## LAND NORTH OF GROBY ROAD, ANSTEY

### DRAINAGE STRATEGY TECHNICAL NOTE 15 MARCH -2021

Figure 2: An extract from the proposed drainage strategy demonstrating the connection of the proposed outfall ditch to the wider catchment.

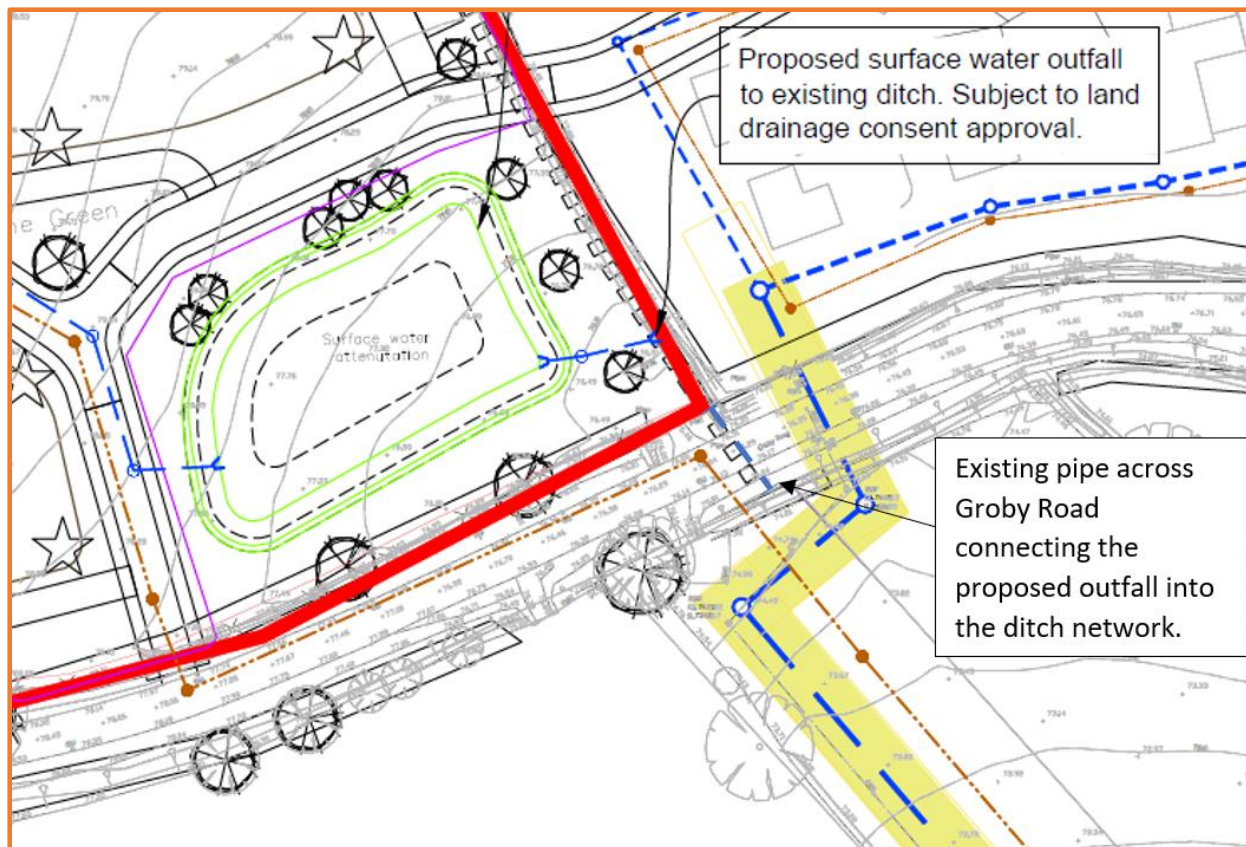
*details demonstrating the connectivity from the ditch on the southern boundary of the site are necessary. Should surface water discharge into a Severn Trent Water (STW) sewer here, evidence would be required demonstrating consultation with STW with support in principle.*

7. Figure 2 demonstrates an extract taken from the proposed drainage strategy ADC1468-DR-502. This has been overlaid with additional details on the connection of the proposed outfall ditch to the wider catchment.

8. The figure highlights the location of the existing connecting pipe in its route across Groby Road and its outfall via the headwall to the south of Groby Road into the existing ditch network.
